18 October 2024  
Our Ref: 21479D.2DK\_Submission to IPART

**Re: IPART's Review of Draft West Dapto Development Contributions Plan 2024  
Submission on behalf of Esker Pty Ltd and Woodcote Developments Pty Ltd**

Figure 2 Community Centres/Halls Spatial Analysis from Places for the Future with additional sub-district facility

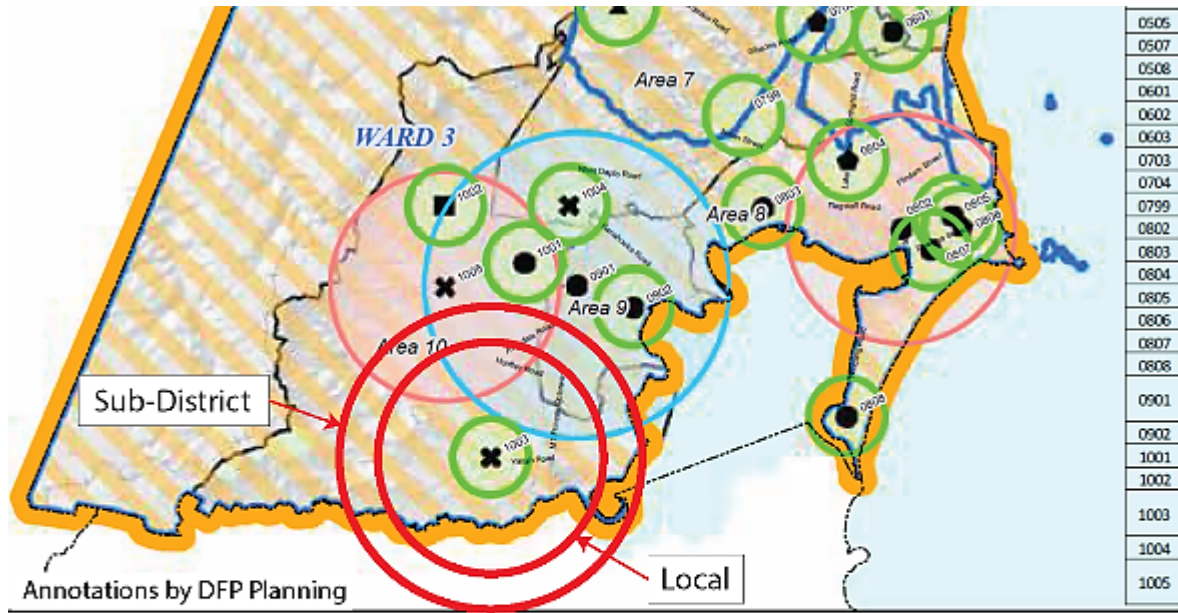
We have overlaid the recommendation in the *West Dapto Social Infrastructure Needs Assessment and Gap Analysis* for a sub-district facility on the spatial analysis contained in *Places for the Future* – Refer **Figure 2**. This clearly illustrates that a sub-district scale facility will have a significant catchment overlap with Planning Area 9 and the Bong Bong Town Centre in Planning Area 10.

**Figure 3** shows that the Dapto Ribbonwood Centre in Area 9 is well used, but notes that it has additional capacity to accommodate future community demand. Its catchment overlaps with the eastern end of Marshall Mount. Council should explore this spare capacity which could reduce the additional community space needed in Marshall Mount.

Council should also explore the option of providing two local centres utilising the North Marshall Mount Road progress hall and the CF05 (as located and sized in the current CP 2020), then two neighbourhood facilities would be available which still gives good coverage of Area 10 catchment as illustrated in **Figure 3**.

Figure 4 Extract of West Dapto Structure Plan: Source - West Dapto Vision 2018

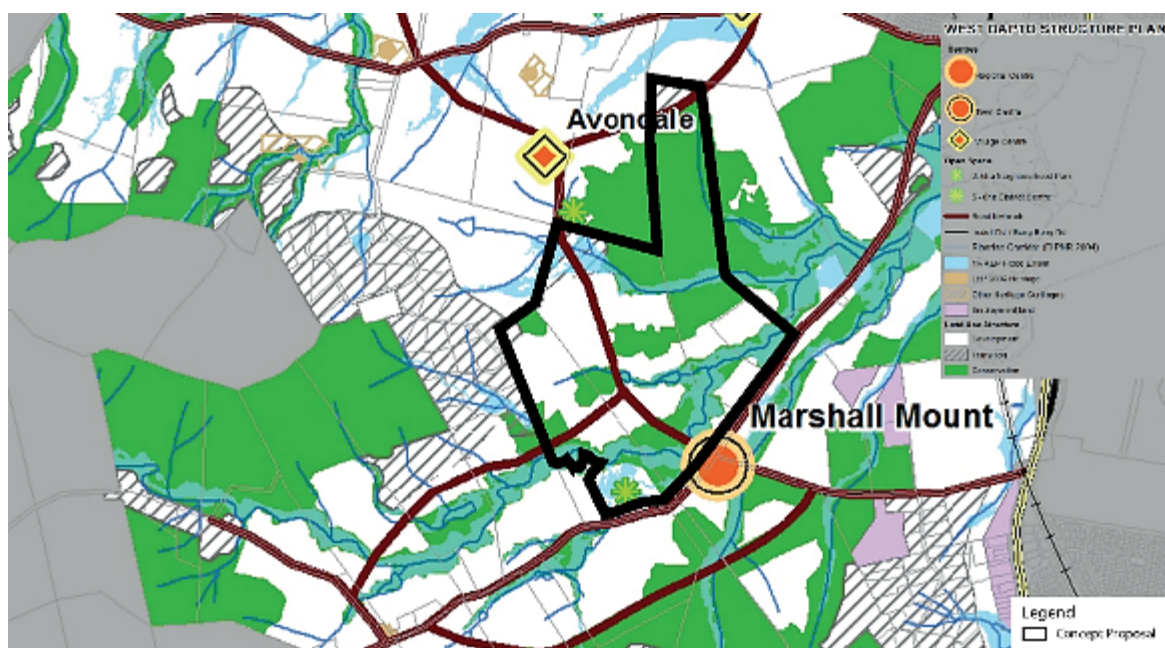
The West Dapto Vision 2018 includes a Structure Plan which illustrates the road typology / hierarchy planned for the WDURA. An extract of the Structure Plan is provided in **Figure 4**. This includes an east-west aligned road to the north of and roughly parallel with Marshall Mount Road, as annotated in **Figure 4**.

The east-west link road (gold shading) is a Type 3 road which will be 2 lanes as illustrated in Figure 6 of Chapter D16.

These characteristics indicate that the road is an important part of the WDURA, in particular Stage 5, and it should therefore be included as an infrastructure item in the Contributions Plan.

Figure 5 Extract from Chapter D16: Road Typology

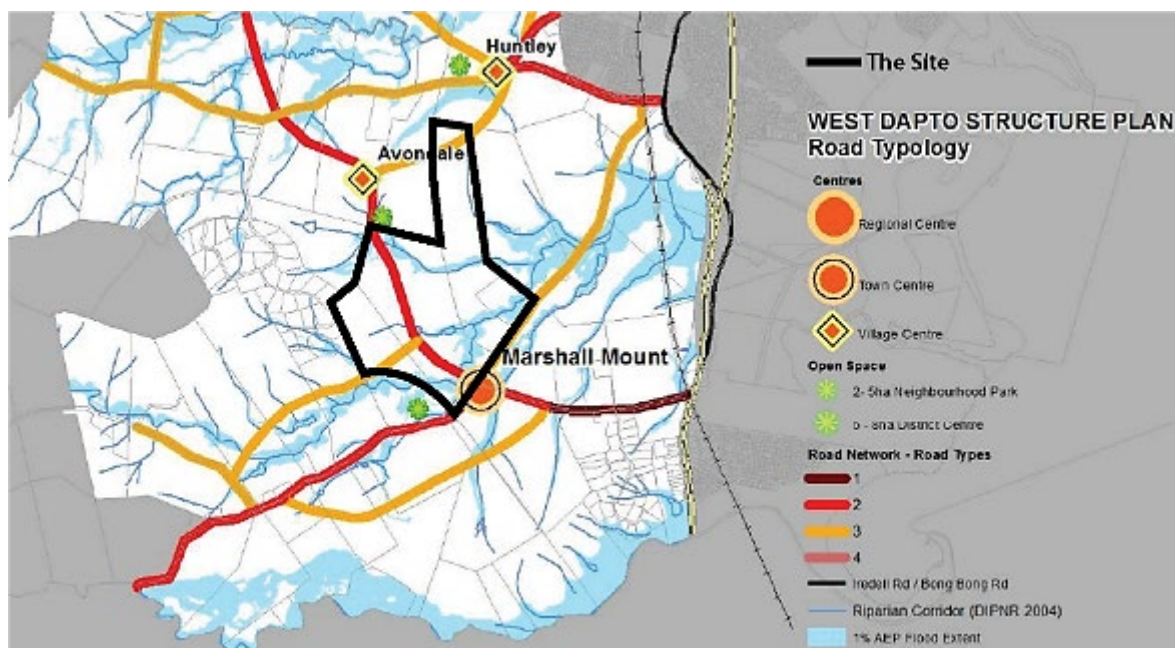
Chapter D16 of Wollongong DCP 2009 illustrates the road typology for West Dapto, an extract of which is provided in **Figure 5**.

Figure 6 Transport Infrastructure - Extract from draft West Dapto Contributions Plan 2024

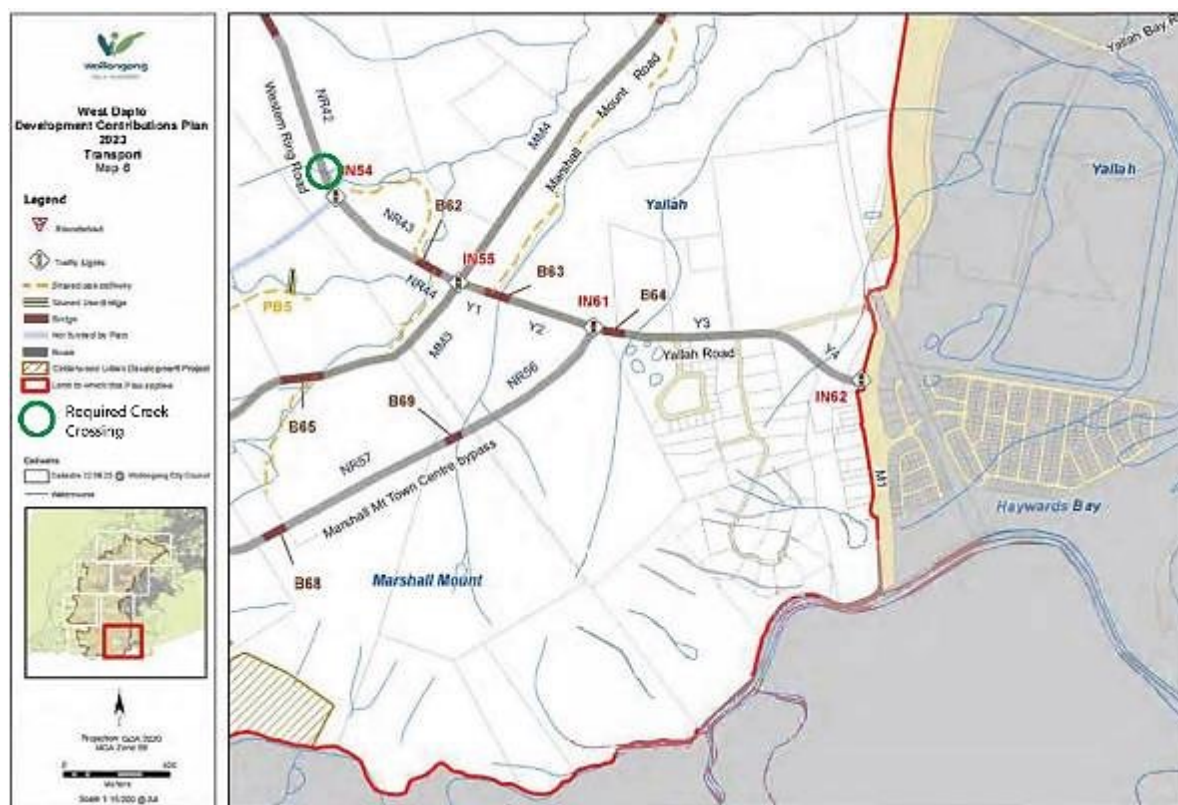
**Figure 6** has been annotated to show a bridge over Creek C1 along the Western Ring Road (segment NR42) which is not included in the draft CP 2024 (or the current CP 2020).

Council's post exhibition report recognises a crossing over the C1 creek corridor is needed, and has stated it will be a bridge (page 7 of Attachment 1). Council's 80% road design for the Western Ring Road proposes a culvert over this creek (not a bridge). However, the post exhibition report does not indicate if draft CP 2024 will be updated to make provision for a culvert (or a bridge) over Creek C1. IPART should review draft CP 2024 to ensure that is included.

The DA (as lodged) has planned for a culvert over the upper extent of the C1 creek which has been estimated at a cost of approximately \$2.5million. Given the fact that the Western Ring Road is a road funded under the Plan, then a culvert for C1 should also be funded. This approach is consistent with the funding of other creek crossings along the alignment of the Western Ring Road.

Figure 7 Extracts from Transport Map 6 comparing current and draft CP 2024

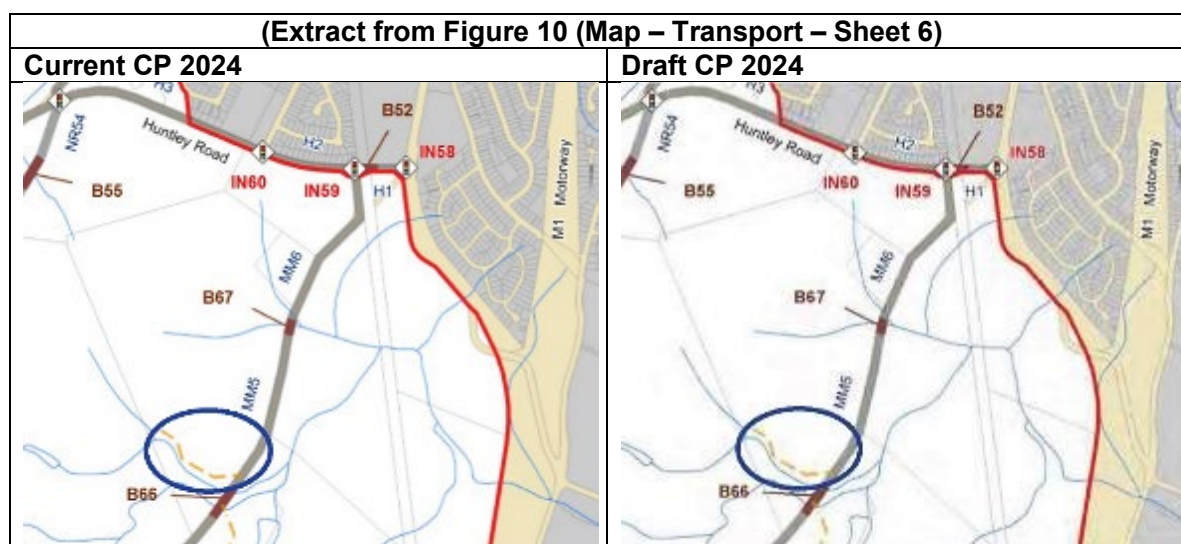
Additionally, there is a segment of TR35 on 84 Marshall Mount Road as shown on Figure 10 in draft CP 2024. As part of the Neighbourhood Plan process for Elm Park, Council has requested that the path be increased in length from 300m to 700m. The increased length has not been reflected in Figure 10 (Map 6) in draft CP 2024 as illustrated in the comparison of **Figure 7** below between the current CP 2020 and draft CP 2024.

TR35 should be added to Figure 10 Map – Transport (Sheet 6) and Schedule 3 – Transport (cost of infrastructure) should be revised for the increased length

Figure 8 Extract from RPS Urban Design Series of plans showing additional parks

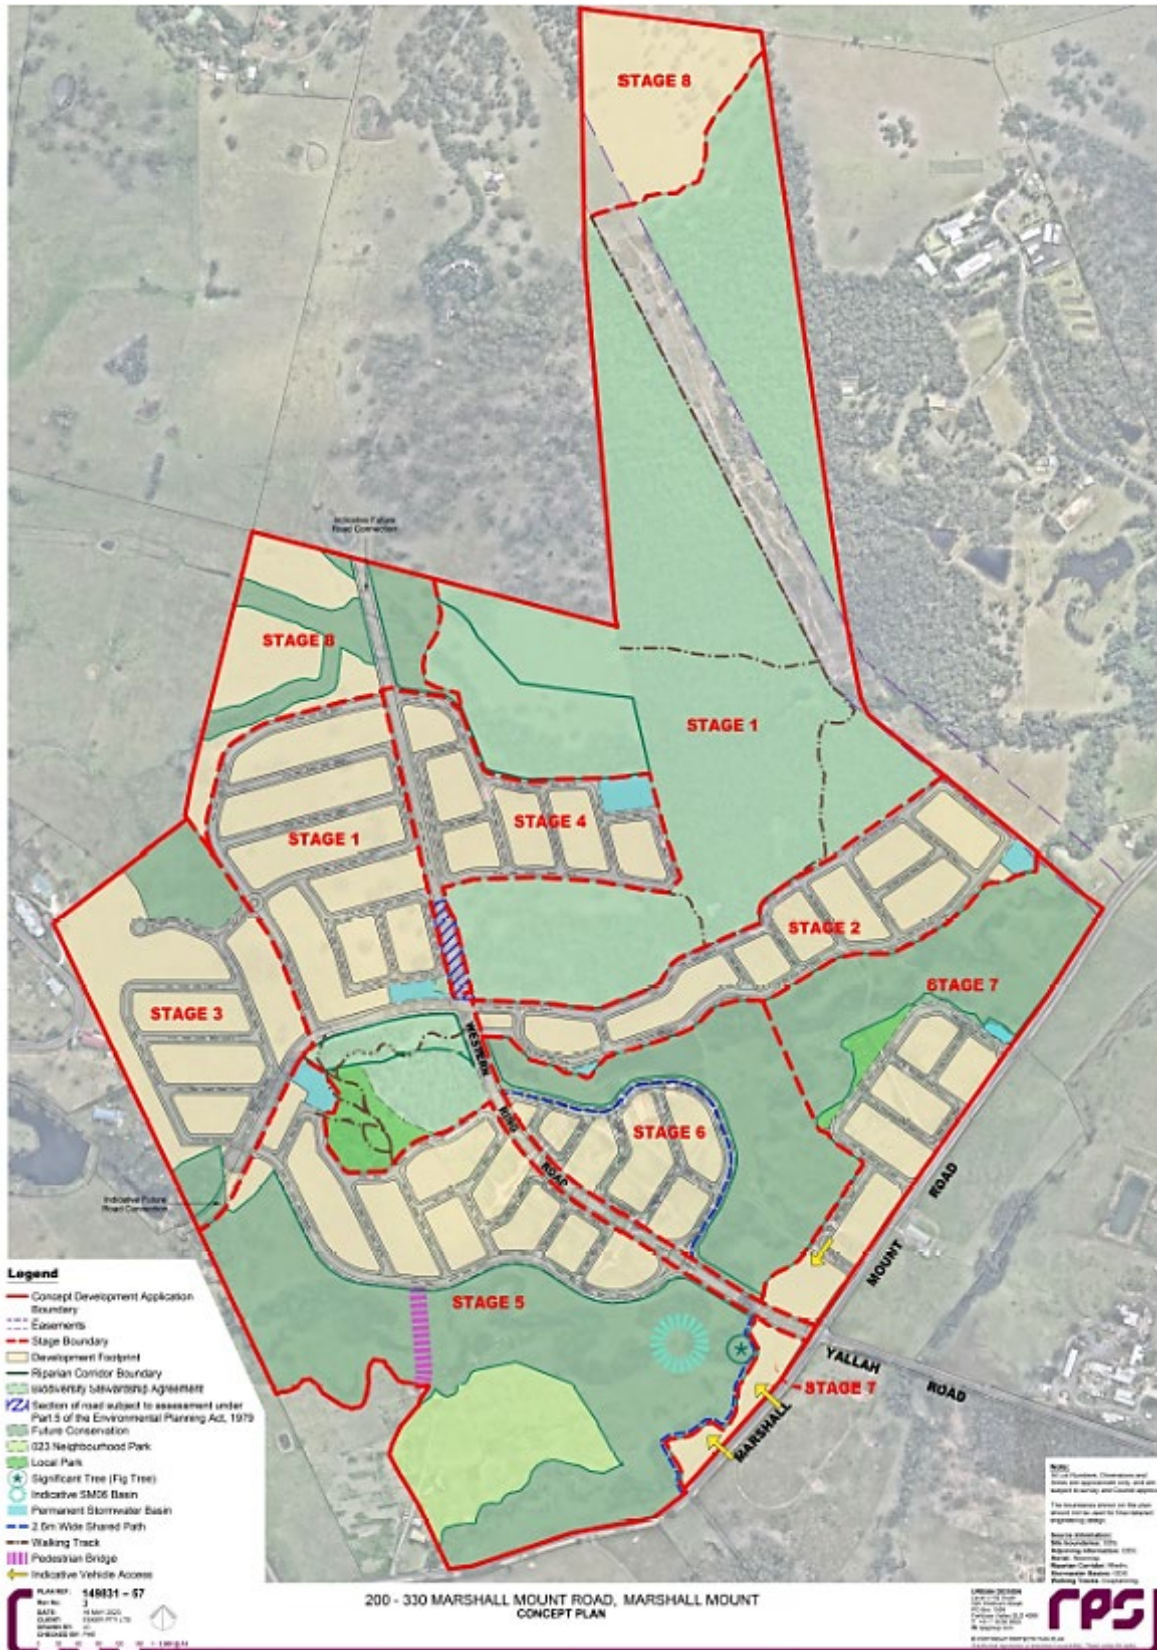
The Concept and Stage 1 DA for Highgate Hills includes two new local parks designed to serve a 600m catchment and as illustrated by the light green in **Figure 8** overleaf (being an extract from the Design Plan Series prepared by RPS for the Highgate Hills DA).

Council's post exhibition report (p.16 of Attachment 1) formed the opinion that because these parks serve a small catchment that they should not be included. These parks are planned as part of a Concept DA (DA-2023/481) that is expected to deliver over 1000 lots/dwellings and a town centre and would also serve future residents beyond the boundaries of the DA. These are significant public facilities that serve a wide catchment.

Accordingly, these two local parks should be included in the draft CP 2024 at reasonable valuations.
